Subject: FW: 177 Tomahawk Road

Subject: RE: 177 Tomahawk Road

As discussed, we understand that Dani Nicolson is seeking to include 177 Tomahawk Road as part of the 2GP Variation 2 (Greenfields) process. We have previously provided a preliminary geotechnical appraisal of the site based on an engineering geological assessment and desktop review of hazards (ref. 210891, dated 14 Dec 2021). Please refer to that report for further details.

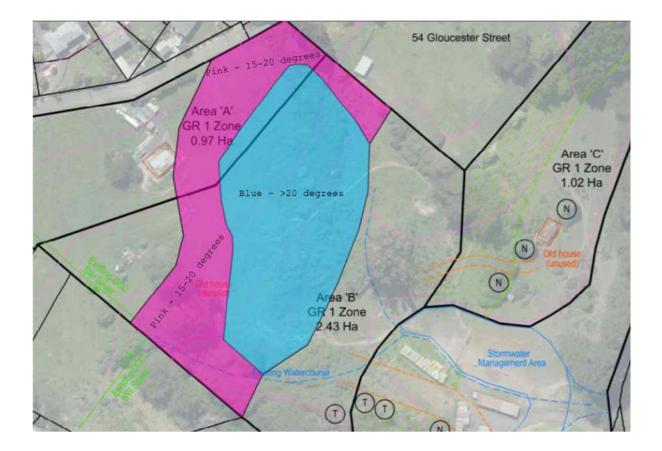
Stantec assess the site as high level hazard and the main concerns are as follows:

- 1. Liquefaction Domain C risk on the flats settlement and lateral spread risks.
- 2. Land instability (landfill) on the flats.
- 3. Although not listed as a hazard, the slopes are very steep and are likely to present land stability risks with such a dense format as GR1. Stantec consider that global stability of slopes >20 degrees could be affected by development, especially earthworks and groundwater changes.

- 1. The structure plan shows that the Domain C liquefaction risk awareness area coincides with Development Area D which will be a recreation area only as well as a proposed legal road. The access road will occupy the westernmost extents of Domain C. Liquefaction risks can be mitigated by undercutting and replacement of susceptible soils or other engineering solutions if liquefaction risk to the accessway is a credible constraint (i.e. if proven to be applicable following subdivision geotechnical investigations and analysis).

- 2. The landfill areas are not expected to be part of the residential development areas and these can be managed as recreation areas. No significant geotechnical considerations are likely to apply to this area.

- 3. There are no known mapped landslides on the site and no instability was observed during our assessment. We have also reviewed stereoscopic aerial photography which confirms no landslips are present on site in 1947 (Run: SN399 Run S-60). The slopes are steep however a significant area of the site that is proposed for residential development (Areas A and B) is likely to be relatively straightforward for development (e.g. including all of the pink area below which slopes at between 15-20 degrees and the upslope remainder at lesser angles). The blue area slopes at greater than 20 degrees, however provided that rock is present and that foundations are specifically engineered, some residential development in this area is also likely to be possible. The accessway will need to traverse some relatively steep slopes, however there are solutions to enable a sidling road alignment with retaining structures.
